**Re: Response to Comments
City of Greeley's 25th Ave Site (Poudre Ponds)**

The City of Greeley (City) and its Consultant, Wenck Associates, Inc. (Wenck) appreciate your comments regarding the City's 25th Avenue Site (Permit No. M-2002-020), commonly referred to as the Poudre Ponds. This letter addresses the Division's (DRMS) comments dated August 30, 2017, on the Poudre Ponds technical revision submitted by the City on July 28, 2017. We thank you for approving our requests for extensions as we worked through some modeling issues that needed to be resolved. The Project Team's responses herein address the request for additional information on our hydraulic analysis for the spillway design and stability criteria of the riprap.

Figure 2: Schematic of spillway water depth when flow is 933-cfs (normal conditions)

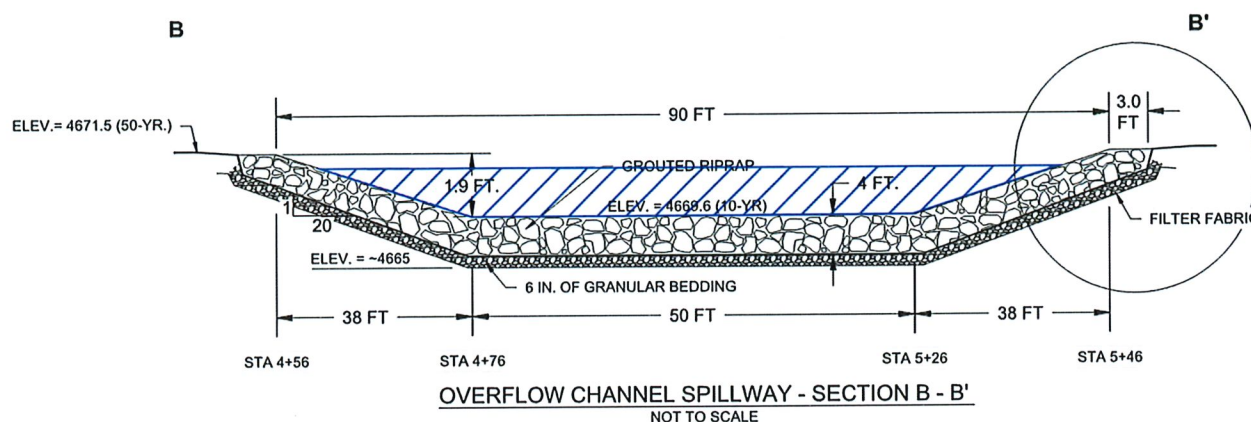
Comment 2: *The Operator states to confirm the stability of the design a worst-case scenario was determined to analyze the stability of the structure versus extreme velocities and shear stress. Please provide the Division with a copy of the worst-case scenario hydraulic analyses used to design the proposed spillway for review.*

The worst-case scenario was determined based on the greatest expected discharge that the spillway would receive assuming the Cachle la Poudre River 100 year in-channel velocity of 13.25 fps were directed into the spillway crest. This condition is shown in **Figure 2**. A hydraulic analysis of this scenario on the grouted riprap portion of the spillway was completed using Bentley FlowMaster V8i. The inputs and results of the analysis are summarized in **Table 2** and included in **Attachment A3**.

This greatest expected discharge is estimated to be 933 cfs. By creating this scenario, extreme velocities and shear stresses could be calculated along the spillway. The contingency involved with the larger (d_{50} = 24-inch) rock size required under normal (100-year and smaller) recurrence intervals as well as the incorporation of the grout provides suitable stability to prevent significant damage to the structure during these worst-case scenarios.

The calculated velocity and shear stresses in the grouted riprap portion of the spillway during this worst-case scenario are 6.26 fps and 11.61 lb/ft², respectively. Both values are within the 15-18 fps maximum permissible velocity and 10-12 lb/ft² maximum permissible shear stress allowable for a grouted riprap spillway. These design criteria are presented in the response to Comment 3.

Figure 1

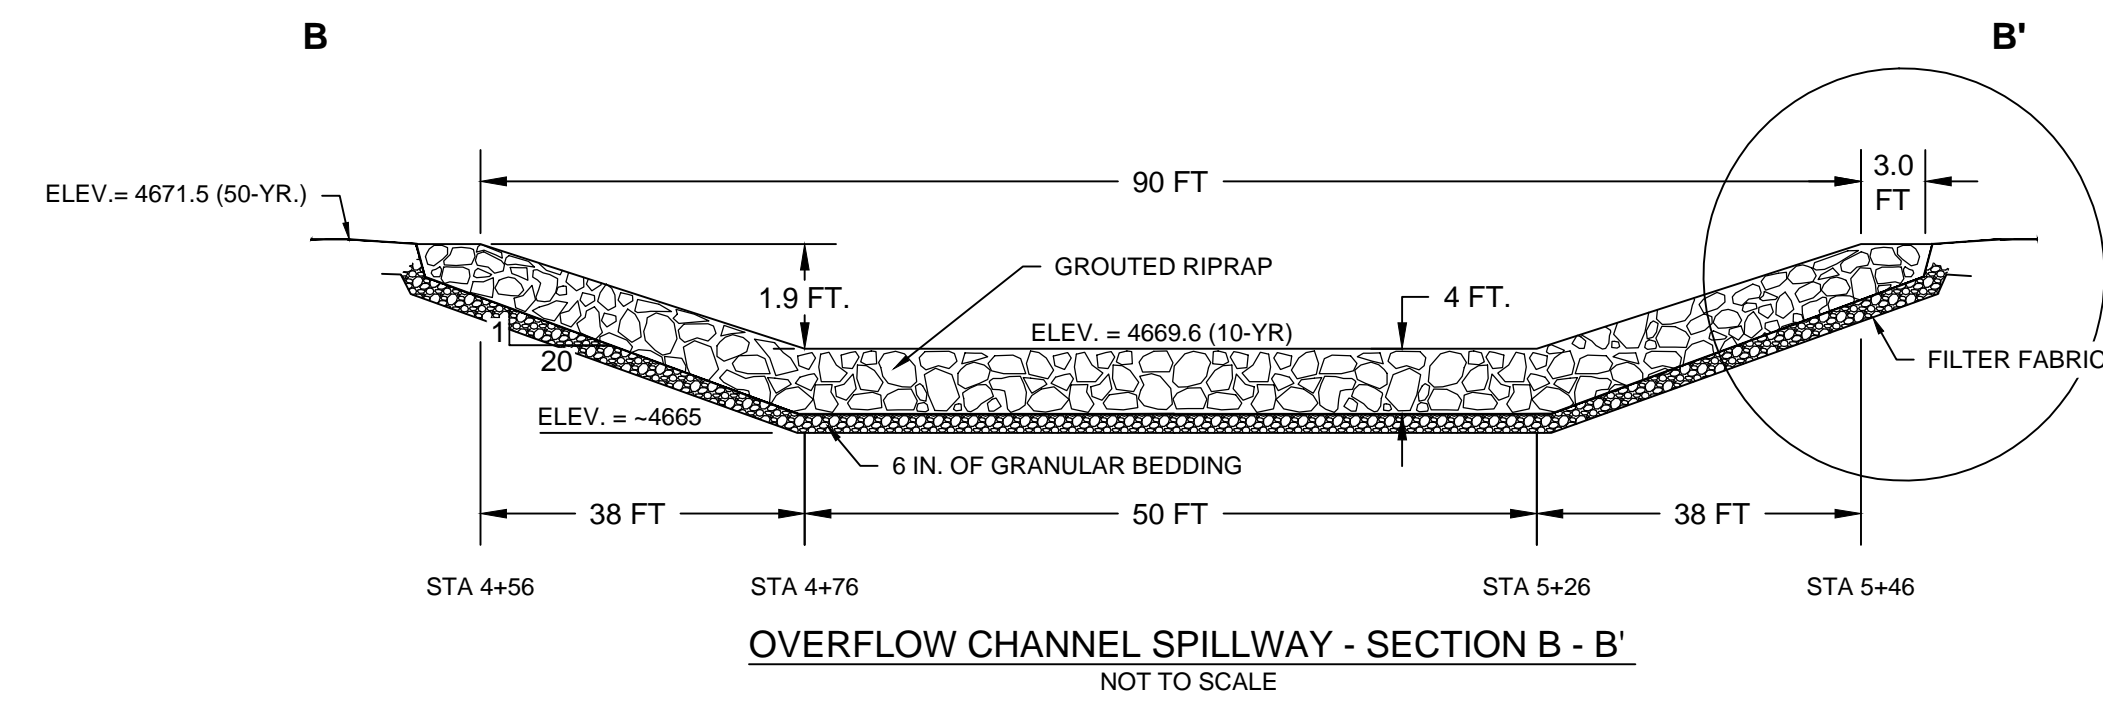
Comment 1: *The Operator states parameters associated with flooding that lead to erosion (shear stress and velocity) were analyzed for a variety of design storms (2-year through 100-year) and an optimal spillway design was determined. Please provide the Division with a copy of the hydraulic analyses used to design the proposed spillway for review.*

A proposed conditions model was created by modifying the existing conditions model to reflect the proposed structure's topography. **Attachment A1** provides a table of the model predicted output from the hydraulic analysis at the location of the proposed inflow point (model cross-sections 51171, 51151, 51101, and 51081) for various recurrence intervals (2-year, 5-year, 10-year, 25-year, 50-year and the 100-year). **Figure 1** shows the location of the cross-sections in the table, which are located both upstream and downstream of the proposed spillway.
